3-5 Help Street, Chatswood – Gateway Determination Report

November 2020

Published by NSW Department of Planning, Industry and Environment

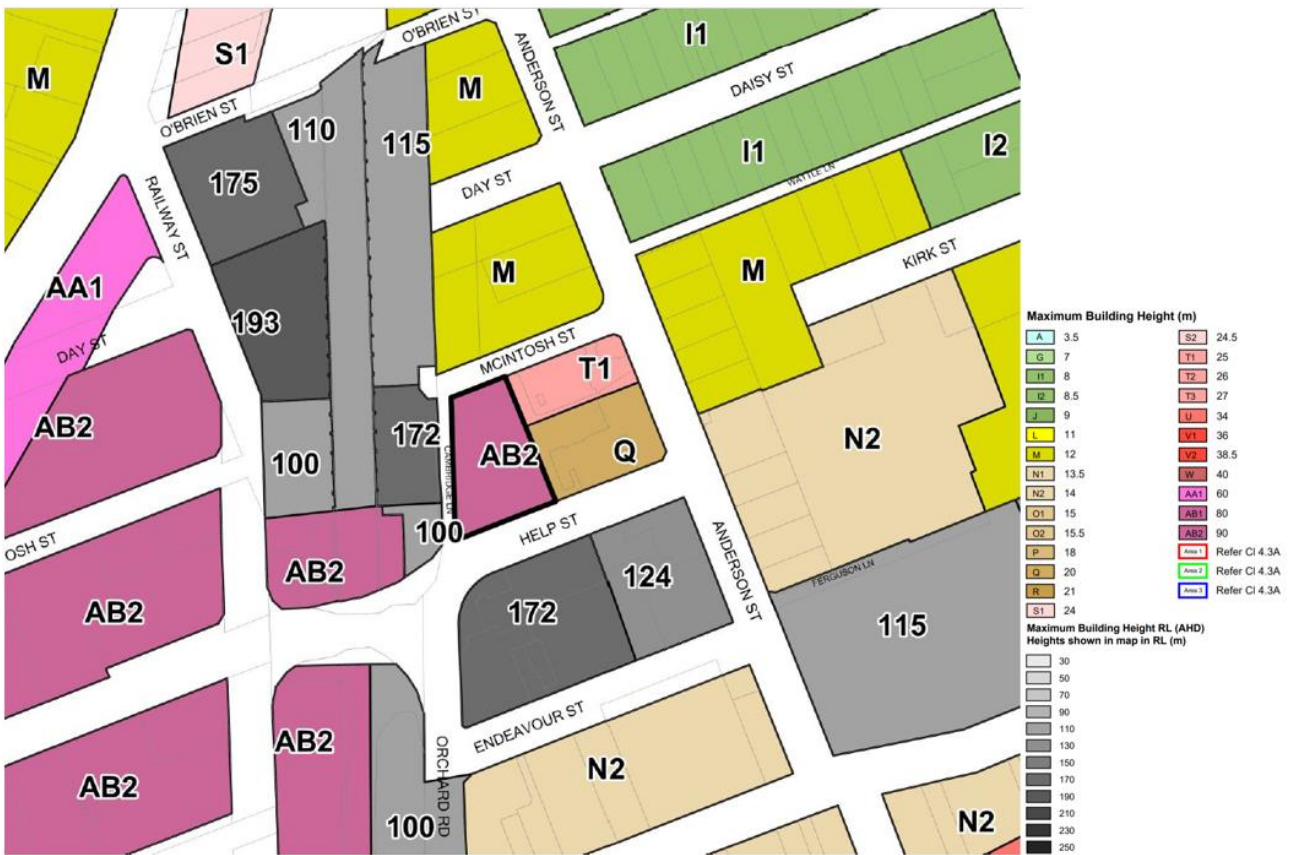
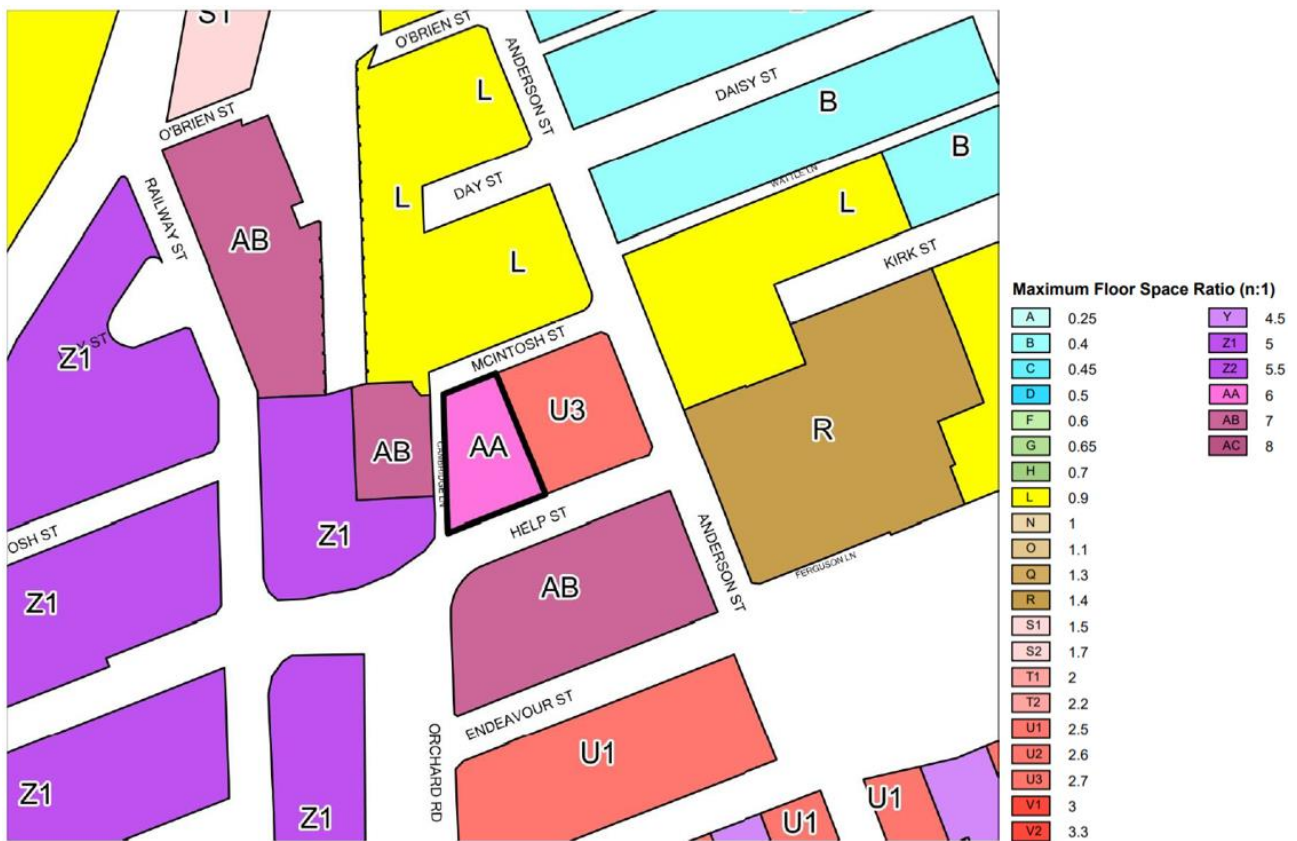
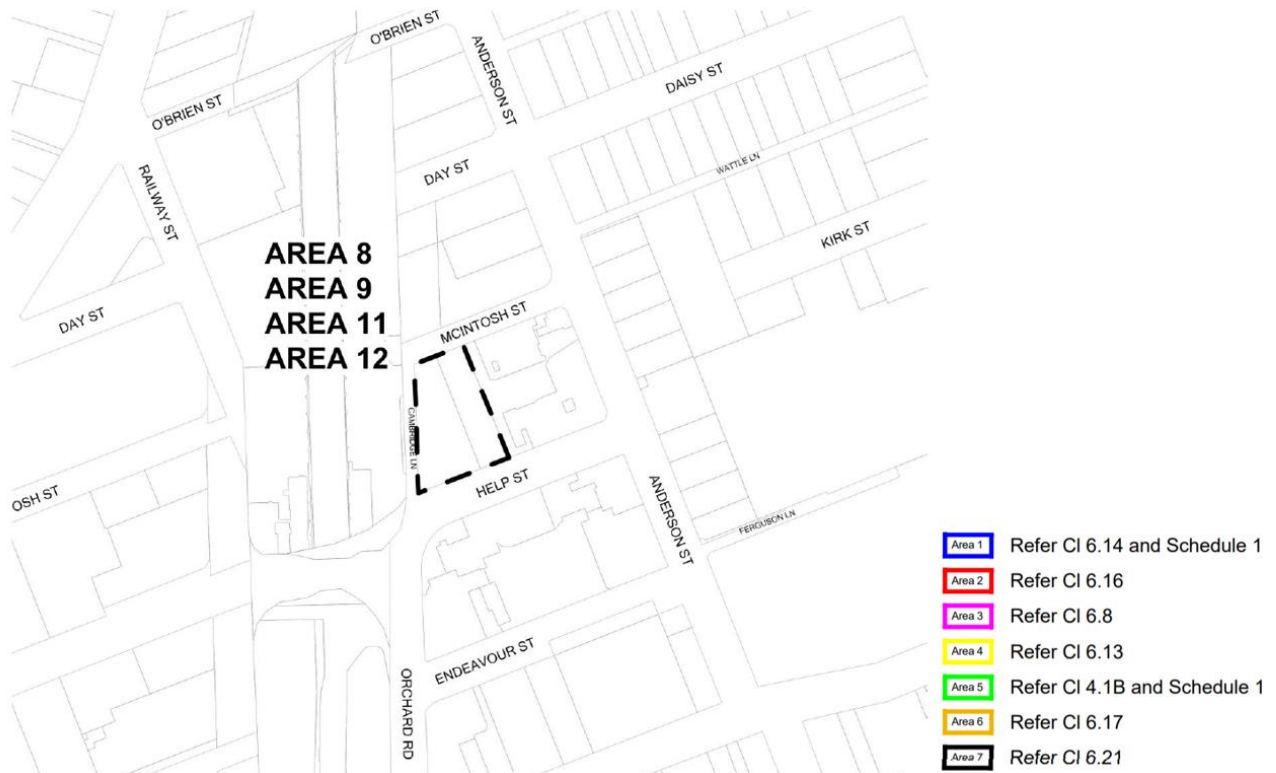
The maps submitted are considered appropriate for Gateway assessment and public exhibition. The maps will be required to be consistent with Department standard should the plan proceed to finalisation.
